Narrative Testimony for the M3 Eagle Water Right Application

Dennis Owsley

May 11, 2009

This narrative testimony was developed in response to the April 1st memo prepared by HLI in response to our March 2nd Staff Memorandum. I co-authored the March 2nd Staff Memorandum and appreciate this opportunity to provide testimony in response to the comments provided by HLI in the memo.

Exhibit 33T

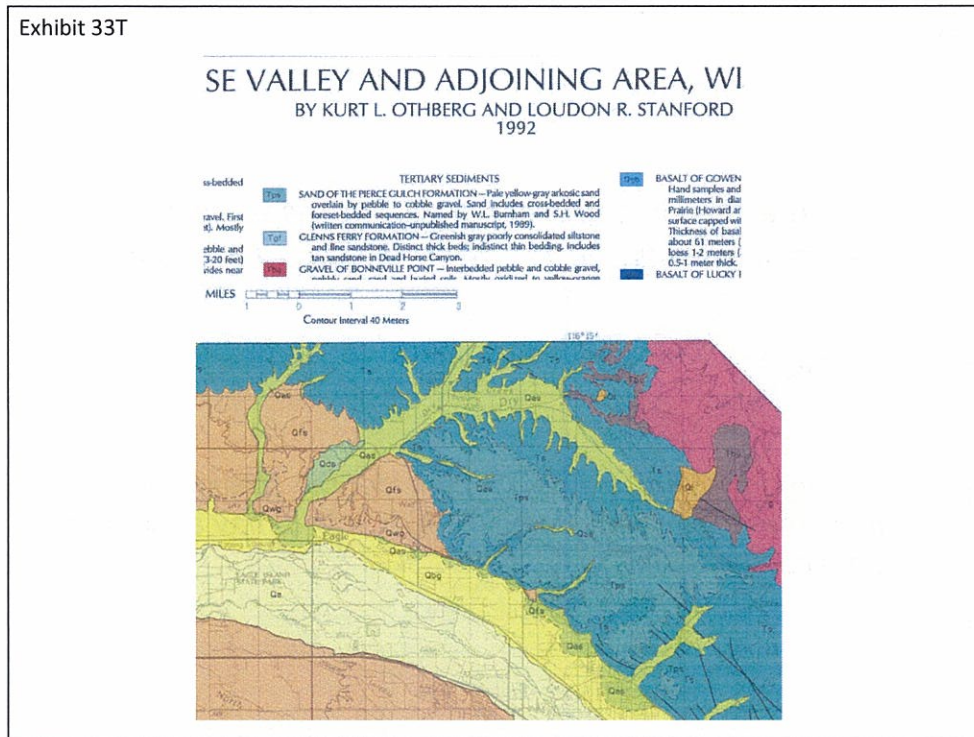
These two images are clips are from the geologic map included by M3 in the submittal of supporting documentation for this water right (Exhibit #33T). We referenced this map when describing the Pierce Gulch Sand in our staff memo. In response to our description and citation of this map, HLI states on page 3 of Exhibit 45

The staff referenced the Othberg and Stanford map as it was the only published geologic map submitted in support of this water right. The PGS is shown as an outcrop on this map and is specifically defined in the legend of this map.

Again, the staff referred to the PGS as a Formation based on the description on the geologic map HLI provided to the department. In addition, it is inconsistent for HLI to claim the Pierce Gulch Sand is not a Formation, when we heard Dr. Wood's April 24th testimony referring to the Pierce Gulch Sand as a formation.

Figure 4

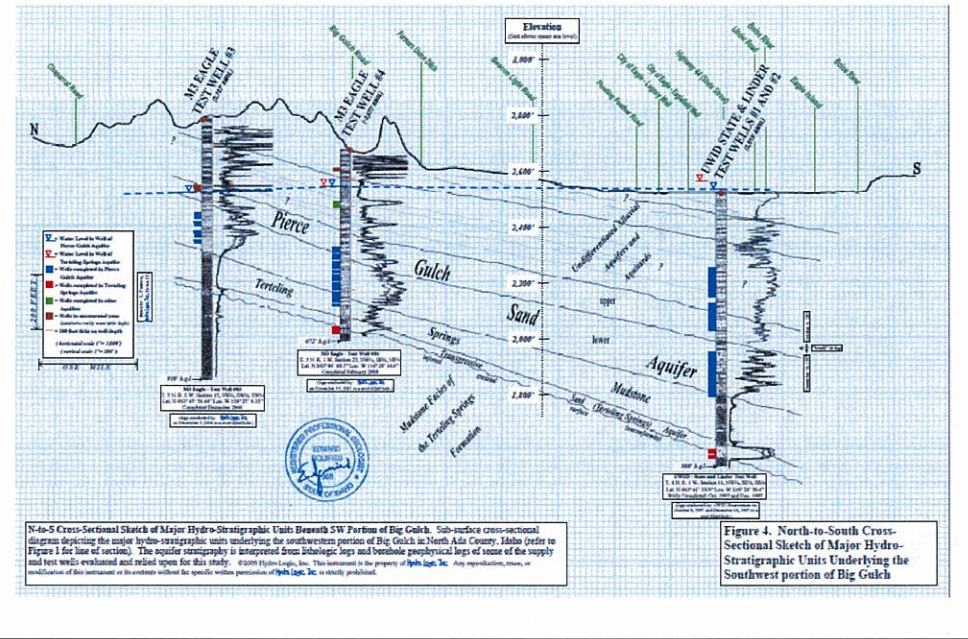
The base of the aquifer is one of the two boundaries that HLI states they have currently defined. However, Figure 4 of Exhibit 44 does not indicate the base of the aquifer is fully defined beneath the M3 property. For example, look at Test Well #4, specifically at the lower completion of the well. Terteling Springs Mudstone is drawn through the bottom of the aquifer in this well. Test Well #3 and Test Well #4 are the two wells in which we heard Mr. Squires testify that they had “{QUOTE} great certainty”{END QUOTE} in the correlation of geologic units between them. Even with what is considered ‘great certainty’ in correlating units under the M3 property using the high quality borehole data that exists on the property, some inferences and interpretations must be made to correlate the geologic units. These interpretations get larger as you move further away from the M3 property due to the lack of high quality borehole data.

Figure 4

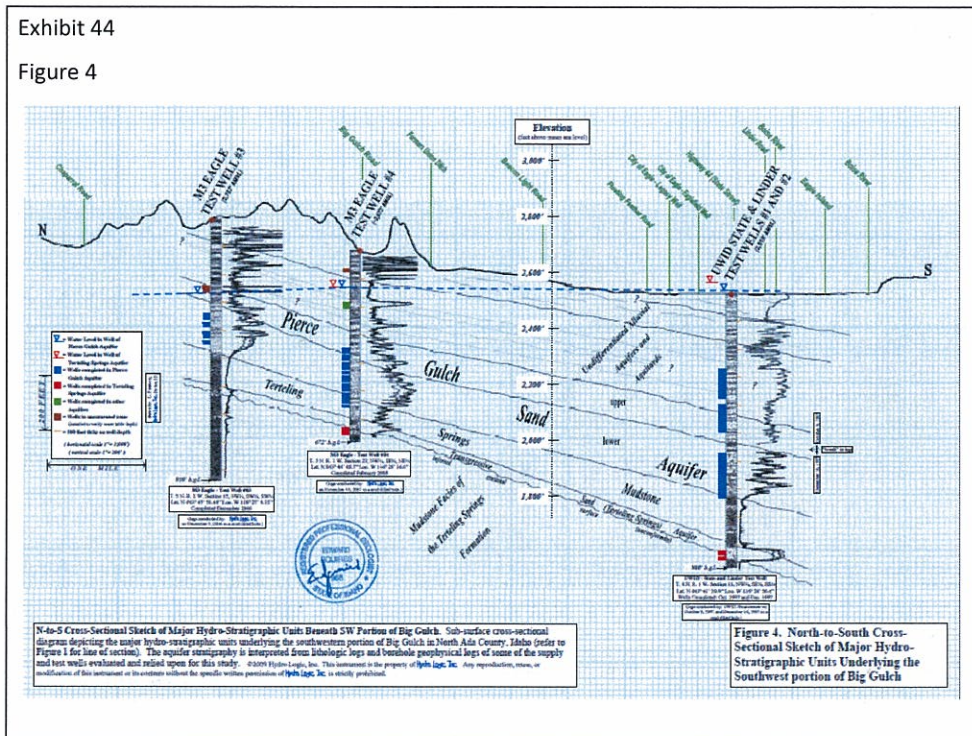
This is the same slide again, however, I would like to point out two additional items related to this slide. First is the identification of the target aquifer in the UWID State and Linder Test Wells. The top of the Pierce Gulch Sand Aquifer in this picture is hard to distinguish in the geologic and geophysical logs between what is identified as the overlying “Undifferentiated alluvial aquifers and aquitards.” The fact that a screened portion overlaps the boundary line drawn further supports this observation.

The depiction of the thickness of the Pierce Gulch Sand Aquifer in this figure is inconsistent with other HLI documents. For example, Exhibit 12, The Re-Analysis of 16 Aquifer Tests Report, identified the Pierce Gulch Sand to be 525 feet thick at this location. However, this figure shows the Pierce Gulch Sand Aquifer to be only approximately 300 feet thick at the same location.

These inconsistencies create challenges when trying to distinguish the Pierce Gulch Sand Aquifer from the “undifferentiated alluvial aquifers and aquitards” that comprise the Treasure Valley aquifer system.

Figure 4

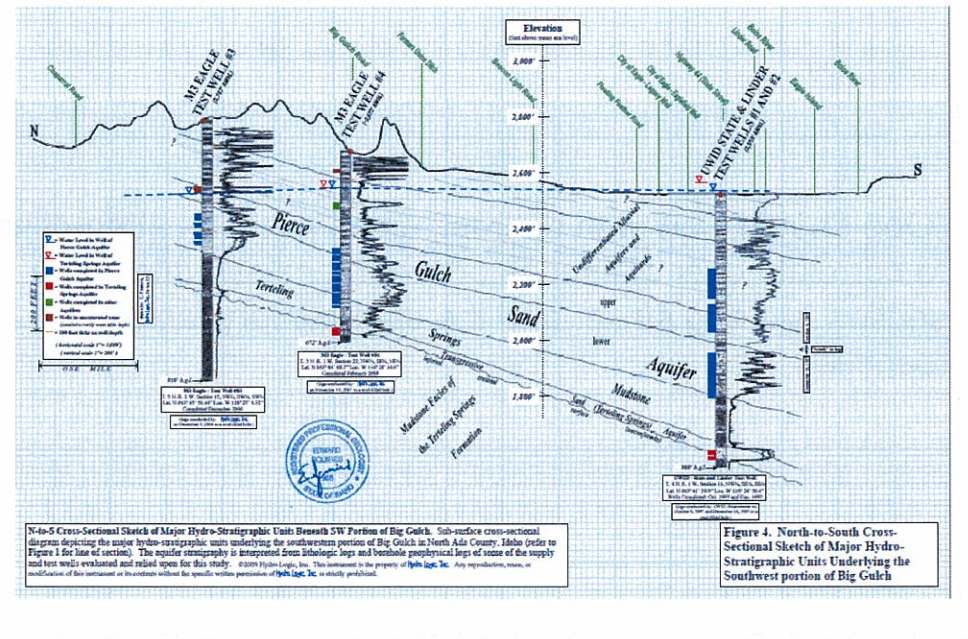
Looking now at Test Well #3 and the completion intervals within it. The elevations of the saturated intervals of this well range from 2453 feet above mean sea level to 2,355 feet above mean sea level. Ground surface identified on this map near Linder Road and the Boise River is labeled at 2,518 feet above mean sea level. Therefore, the elevations of the water bearing zones in Test Well #3 are equivalent to the elevations of water bearing zones that are approximately 65 feet to 165 feet below the Boise River near Linder Road.

Figure 2. Subsurface Seismic Reflection Profiles (from Wood)

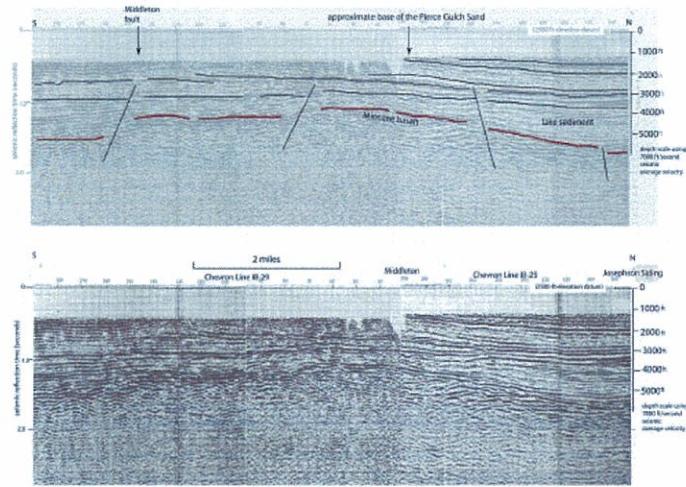
This figure is Figure 2, from Exhibit 45. As Mr. Vincent pointed out in his testimony, the upper 1,000 feet of data for these profiles is not provided, limiting the use of this data to make assumptions regarding the upper 1,000 feet.

We have heard testimony that geologic surface features in the area are rare, limiting the ability to identify or map faults at the surface. We have also heard testimony that wells logs can not indicate the presence or absence of faulting. Considering the seismic survey attempted by BSU on the M3 property was unsuccessful, it appears no data has been collected to support the lack of any faults that may be present in the upper 1,000 feet of the sedimentary section.

In conclusion, there is currently no research that has been conducted to confidently rule out the presence of faults in the upper sedimentary sequence. If faults do exist, they may play an important role in ground water flow in the area. They could serve as either conduits or flow barriers depending on the absence or presence of fault gauge. Or, more importantly in my opinion, could offset sedimentary units, increasing the hydraulic connections between different strata and reducing the hydraulic connection within the same strata.

Figure 1 (Zoomed in on M3 Property)

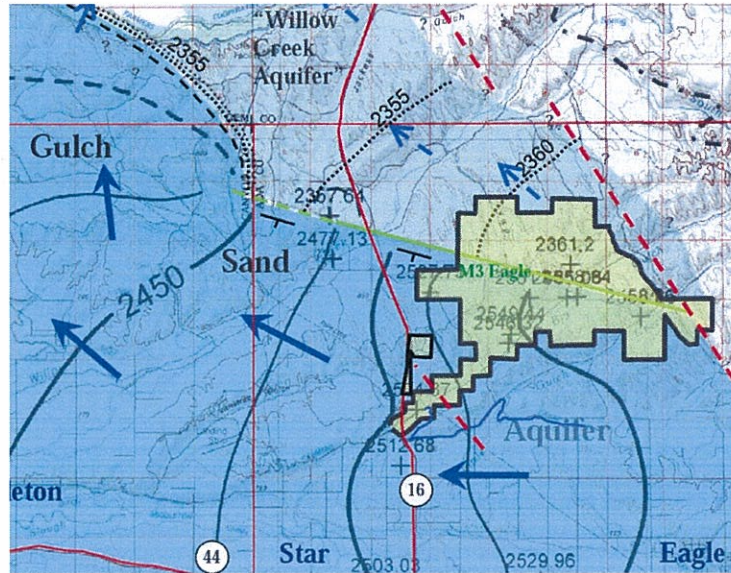
This is a zoomed in image of the previous slide focused in on the M3 area that contains the majority of the data points plotted on the regional map. The “green line” on the map represents a no-flow barrier and has significant importance on the ground water flow direction . Notice at the termination of the line the ground water flow abruptly changes to the north.

Exhibit 44

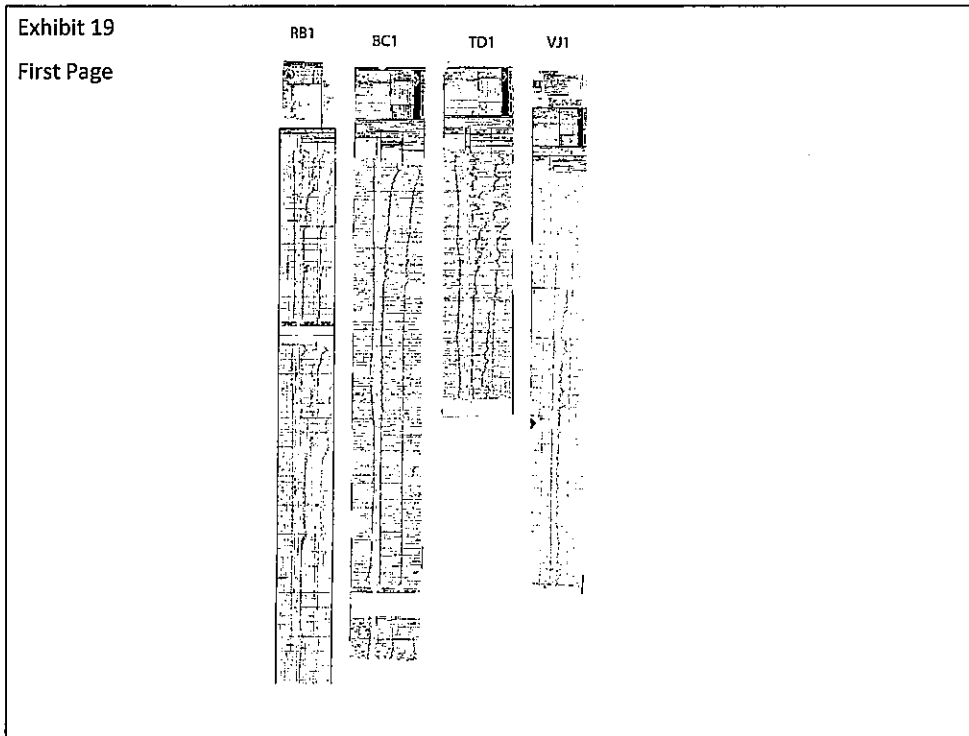
HLI is correct that the Staff did not review the geophysical logs for the mentioned wells in the Payette basin for two reasons. First, the April 1, 2009 memo prepared by HLI is the first and only HLI authored document in which these wells are specifically referenced. The quote that is currently on the screen is the extent of the discussion of these wells in the 2009 submittal. It reads "{QUOTE} *"Indeed, the identified characteristic "geophysical signature" of the base of the Pierce Gulch Sand Aquifer (HLI, 2007) appears to be present in deep petroleum exploration bores beneath the cities of Meridian, Caldwell, and Payette, Idaho (S.H. Wood, personal communication, 2009) suggesting that the Pierce Gulch Sand Aquifer is extensive to not only the Payette River Valley but also to the Snake River Valley."*{END QUOTE}

The second reason the Staff did not review the geophysical logs for the Daws and Johnson wells is because the logs were not properly identified and difficult to read. The slide shown here is are the geophysical logs as they were submitted to the department. Several issues made the review of these logs difficult. First it is unclear as to what the labels "RB1", "BC1" "TD1, and VJ1 represent. Second, there was not a map to accompany these plots to show their location. And third, the legibility of the actual data on the plots was difficult to read.

The department was unaware of the significance of these plots until we read the April 1, 2009 memo from HLI.

Exhibit 2
Figure 7

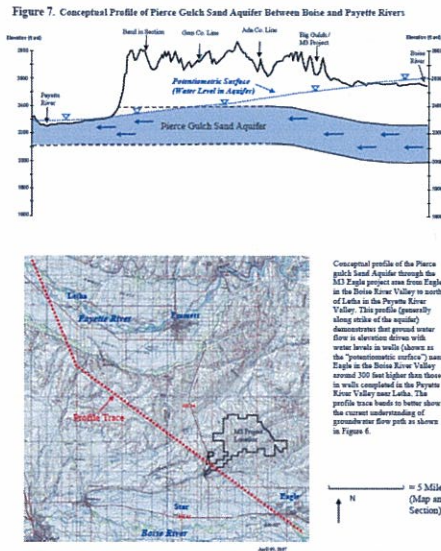
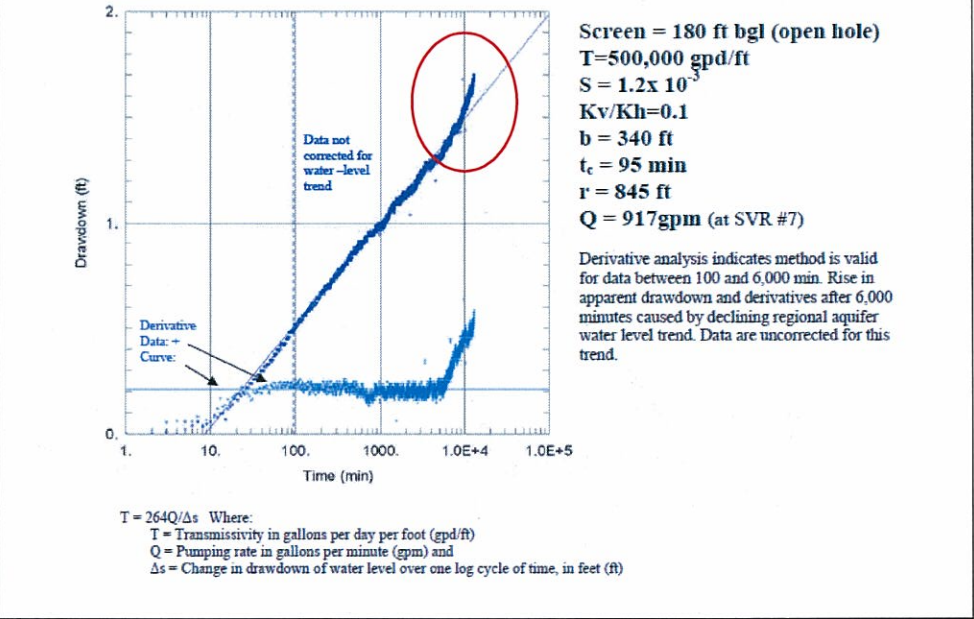
This slide shows the two hydrogeologic profiles of the Pierce Gulch Sand Aquifer submitted in support of this application that extend into the Payette basin. Although similar, the two profile lines are not in the same location. They do however, follow the general strike of the aquifer as define to the northwest. Therefore the change in dip can not account for the different depths of the Pierce Gulch Sand Aquifer beneath the Payette River. The differences between the two profiles suggests additional information is necessary to better define this aquifer on a regional scale.

Figure 6. Cooper-Jacob Analysis for the Big Gulch Stock Well with Water-Level Trend Corrections

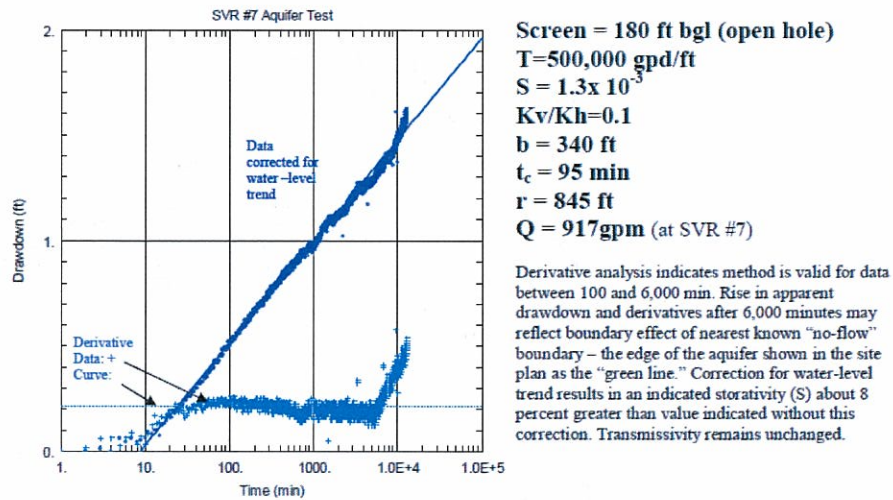
This is Figure 6 from Exhibit 45. HLI responded to our comments in the staff memo by correcting the drawdown data with the regional aquifer trend in attempt to account for the late rises in water levels. Note the increase is apparent in the corrected water levels as it was in the original submittal. In addition the text on the graph states "{QUOTE} Rise in apparent drawdown and derivatives after 6,000 minutes may reflect boundary effect of nearest know "no-flow" boundary – the edge of the aquifer shown in the site plan as the "green line." {END QUOTE}

The presence of a hydraulic boundary is suspected by department and HLI. A test of longer duration would have provided additional information needed to determine the significance of such a boundary.

Figure 27. Theis Recovery Analysis for the Big Gulch Stock Well with Water-Level Trend Corrections

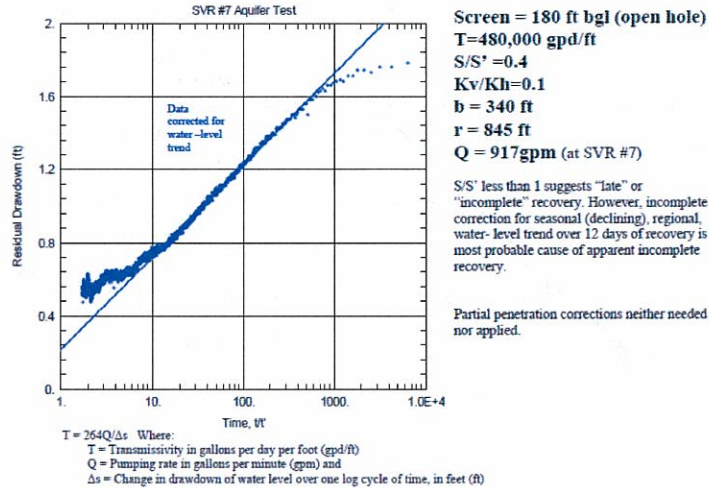
This slide is Figure 27 of Exhibit 44. This plot is a recovery plot of the Big Gulch Stock well. Note the deviation from the blue line on the left side of the plot. This deviation indicated an incomplete recovery in the water levels, meaning the water level did not fully recover to the pre-test level. Again, we commented accordingly in our Staff Memo.

Figure 7. This Recovery Analysis for the Big Gulch Stock Well with Revised Water-Level Trend Correction

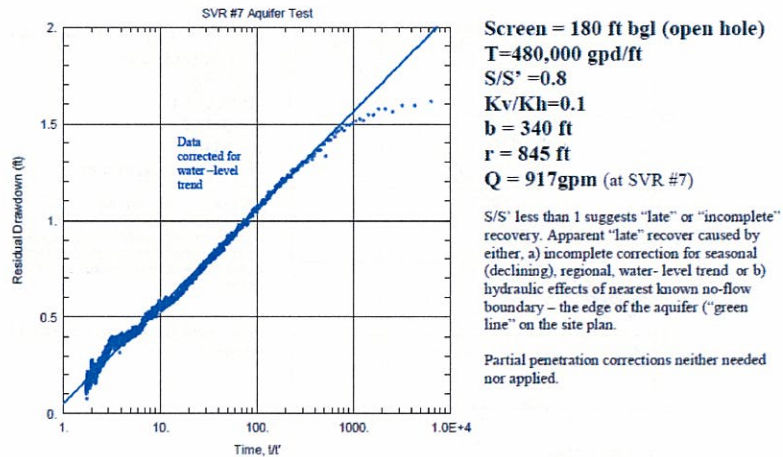
This slide is Figure 7 of Exhibit 45. HLI presented this plot in response to our comments regarding the lack of recovery. This is a plot of drawdown recovery data that was previously shown, but corrected for a trend that was misapplied to the data in the original submittal. Note this correction reduces the deviance from the straight blue line. The data also come closer to approaching full recovery. Possible reasons for the incomplete recovery are stated in the text of this plot that include: "{QUOTE} S/S' less than 1 suggests "late" or "incomplete" recovery. Apparent "late" recover caused by either a) incomplete correction for seasonal (declining) regional, water-level trend, or b)hydraulic effects of nearest known no-flow boundary – the edge of the aquifer (green line" on the site plan."{END QUOTE}

Figure 3

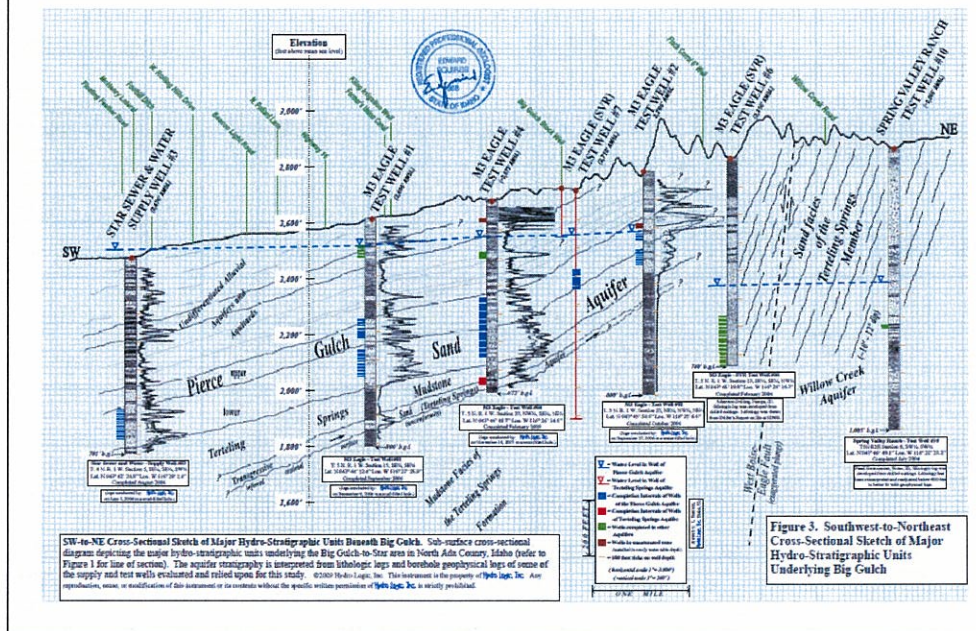
The “{QUOTE} green line” {END QUOTE} is one of the two boundaries that HLI states they have defined. As we heard in Mr. Vincent’s testimony, based on this figure it is unclear as to how the base of the aquifer can daylight on the west side of SVR #6. Additional questions are related to the water level fluctuations across the green line as it appears in this figure that permeable sediments could be in contact across the line.

FIGURE 3

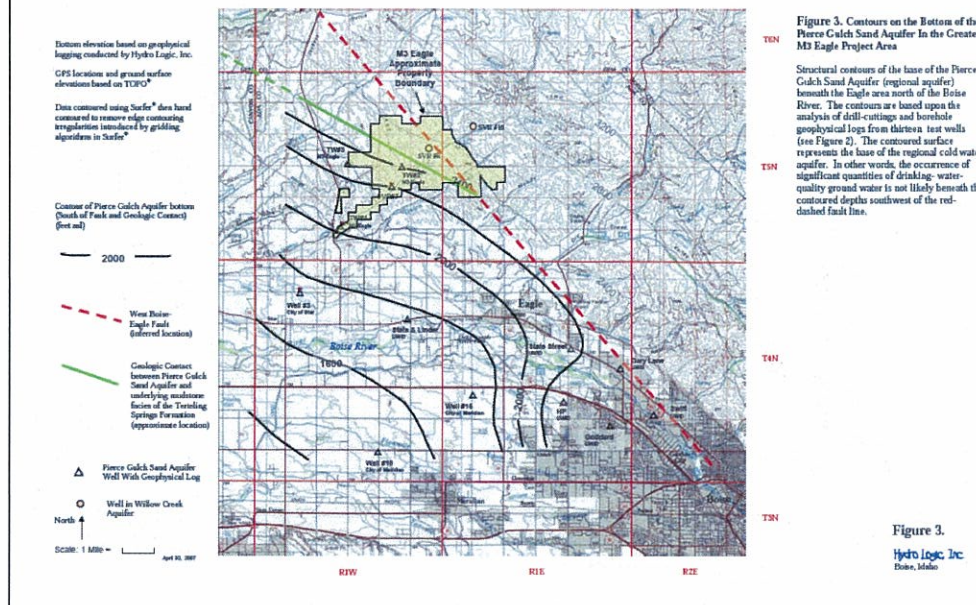
This slide shows figure 3 of the Exhibit 2. The map depicts the elevation contours in which represent the bottom of the aquifer. The bottom of the Pierce Gulch Sand Aquifer is considered equivalent to the top of the underlying thick mudstone. Equating the extent of the Pierce Gulch Sand Aquifer to the extent of the mudstone involves making the assumption that the sediments that directly overlie the mudstone are composed of deltaic sands. As I previously testified, the distinction between the Pierce Gulch Sand Aquifer and the undifferentiated alluvial aquifers and aquitards that exist throughout the region becomes less distinct with distance from the M3 property.

Figure 3-4: Subdivisions of Idaho Group sediments.

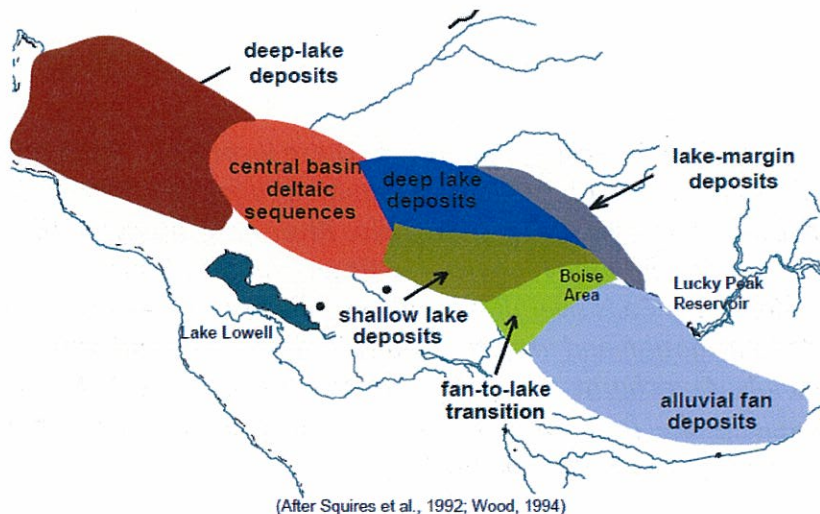
This slides shows Figure 3-4 of the Exhibit 33D. This figure depicts the Subdivisions of the Idaho Group Sediments in the Treasure Valley after Squires, et al 1992 and Wood 1994.

These subdivisions of the sedimentary units is supported through the data and testimony submitted in support of this water right application. Note the gray lobe on the northeast side of the group of classifications. This gray shaded area represents the lake-margin deposits, which would include the deltaic sands of the Pierce gulch Aquifer. The limited extent of the these lake-margin deposits supports the earlier testimony I provided that the lake-margin sediments merge into the finer grained deposits within the basin. This depiction of the sedimentary units within the Treasure Valley indicates the lake-margin deposits are not as extensive as conceptualized by HLI.
